Lindo Mexico Restaurant, [K-19/D144]

7209 Central Ave. NE

Lindo Mexico Restaurant, 7209 Central Ave. NE, Traffic Circulation Layout Architect's Stamp dated 04-05-12 (K-19/D144) with revision stamped 10-31-12.

Re: Lindo Mexico Restaurant Grading and Drainage Plan Engineer's Stamp dated 12-3-11 (K-19/D144)

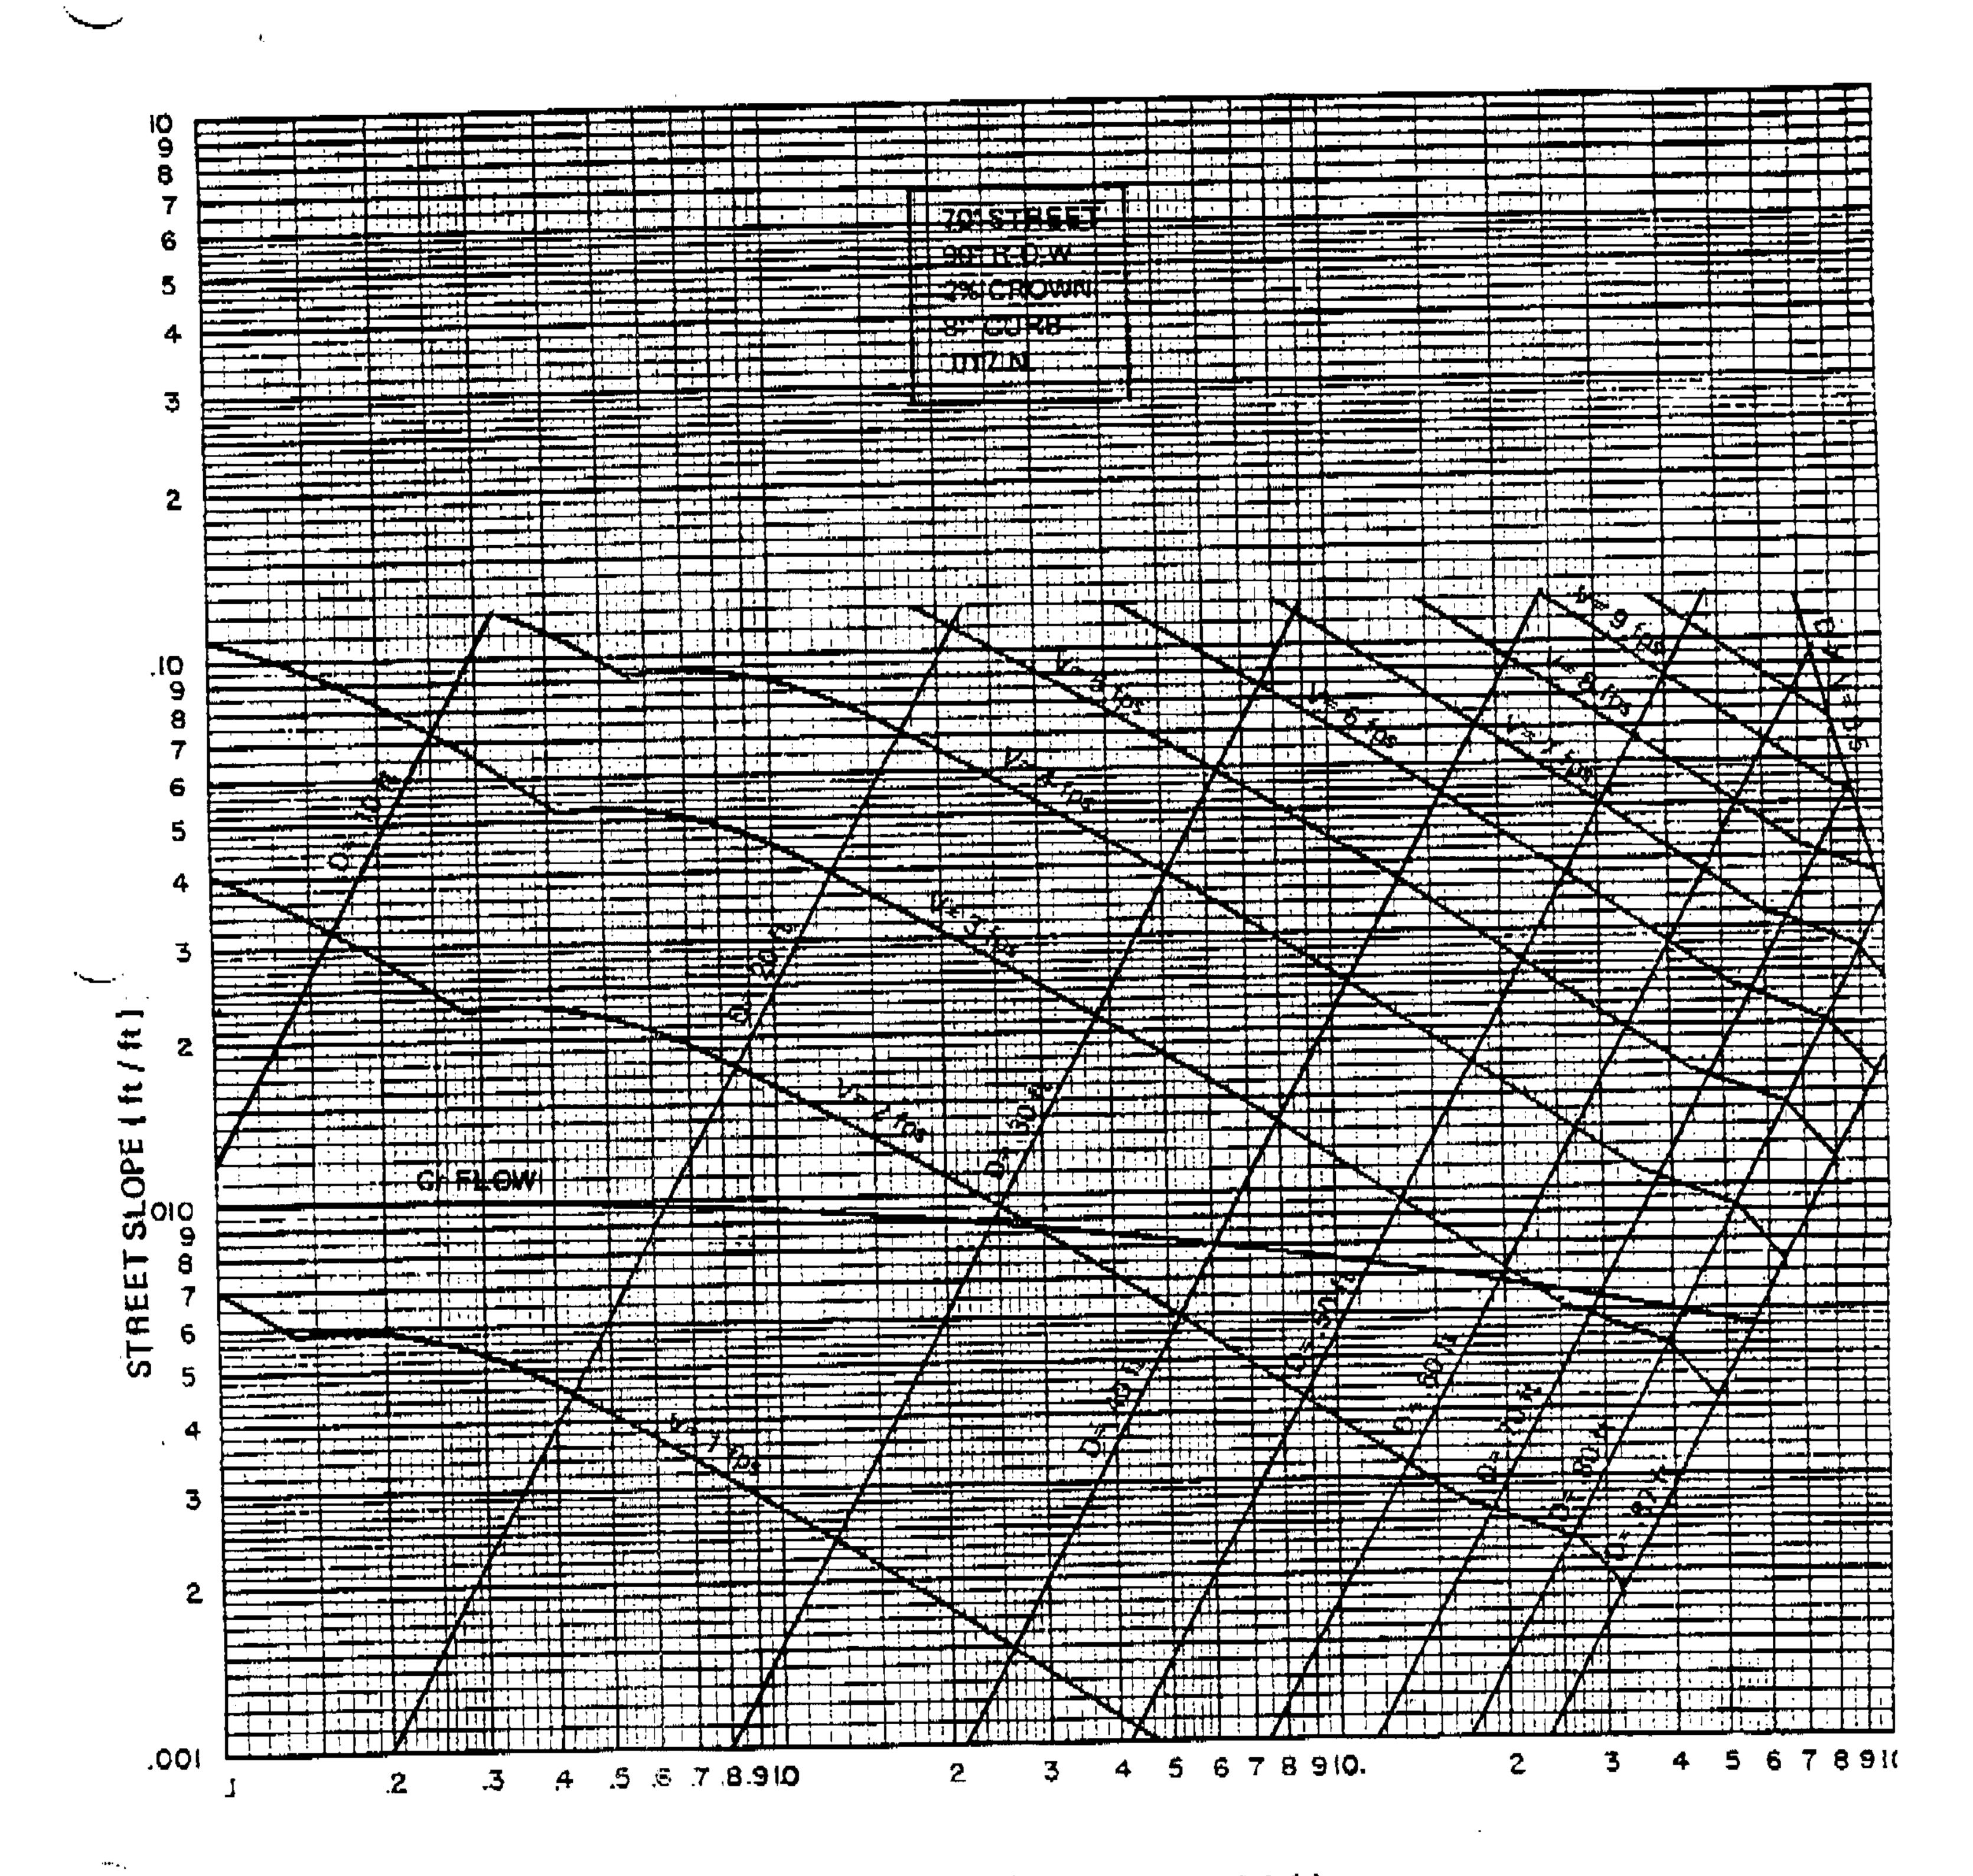
· Central Auc. - W. bound 1.3%

· Flood plain whim curb/R.o.W.

· Existing Inlets 3 double 3 double és up 2 Single As

· Capacity of Street

d= topof curb = .67' => Q = 36 cf5

d= R/W = 0.87' =>

· Using 0.87' depth

1- Single A' = 15 cf5 = 1 single 'D' 1 - Double C = 17 cfs

... 5-inlet Capacity, Exist. = 81 Cfs

Replace Existing Double C' - with Double D' 1:1 ratio 15 cfs: 15 cfs less curb opening Add single D', Cap. 15 cfs >> 1- Curb opening . TOTAL = 81 cf5 + 15 = 96 cf5
